Model: Model A-P3		Date: 27-Nov-01	No.: RG065001
Subject: Service Manual Correction		Prepared by: E. Fukuyama	
From: Technical Services Dept., GTS Division			
Classification:	<input type="checkbox"/> Troubleshooting <input type="checkbox"/> Part information <input type="checkbox"/> Action required <input type="checkbox"/> Mechanical <input type="checkbox"/> Electrical <input checked="" type="checkbox"/> Service manual revision <input type="checkbox"/> Paper path <input type="checkbox"/> Transmit/receive <input type="checkbox"/> Retrofit information <input type="checkbox"/> Other ()

Model: General (GW Models)		Date: 20-Dec-01	No.: RGene010
Subject: Series Print Mode		Prepared by: K. Misugi	
From: Technical Services Dept., GTS Division			
Classification:	<input checked="" type="checkbox"/> Troubleshooting <input type="checkbox"/> Part information <input type="checkbox"/> Action required <input type="checkbox"/> Mechanical <input type="checkbox"/> Electrical <input type="checkbox"/> Service manual revision <input type="checkbox"/> Paper path <input type="checkbox"/> Transmit/receive <input type="checkbox"/> Retrofit information <input type="checkbox"/> Other ()

Model: General RTB		D

Service Parts P/N (PCU)	PCU Serial Number (PCU)	Model on which the PCU is used:
G0652204	051200001 - 060200200	Model A-P3

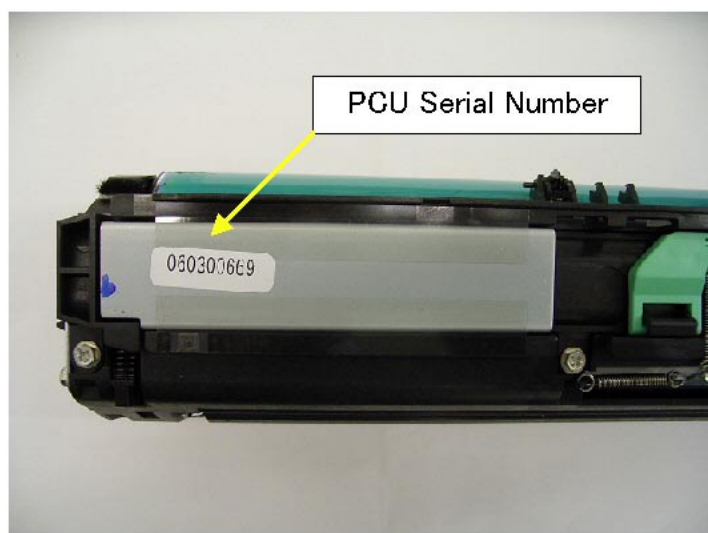
Toner dirtying appears on both sides of the printout just after a new PCU or Maintenance Kit A is installed.

Too much grease was applied to the drum or charge roller during factory assembly. As a result, some of the grease moved to the image area of the drum or roller and attracted toner.

Note: This only occurs on some service parts PCUs or Maintenance Kit A from the “**Affected Units**” list below. It does not occur on service parts drums/charge rollers, or PCUs already inside a new machine.

1. Take 5 all-white copies (A3/DLT).
2. If the symptom occurs, go to step 3.
If it does not occur, the PCU is normal.

3. Take 10 more all-white copies (A3/DLT).
4. If the symptom still occurs, measure the distance between each dirty image.
 - If the distance is about **180mm**: Remove the **drum** and clean the drum surface (dry cloth +alcohol).
 - If the distance is about **44mm**: Remove the **charge roller** and clean the roller surface (dry cloth +alcohol).
5. Reinstall the same part you removed in step 4 (drum or charge roller).
6. Take 5 all-white copies (A3/DLT).
7. If the symptom still occurs:
 - If the distance is about **180mm**: Replace the **drum**.
 - If the distance is about **44mm**: Replace the **charge roller**.
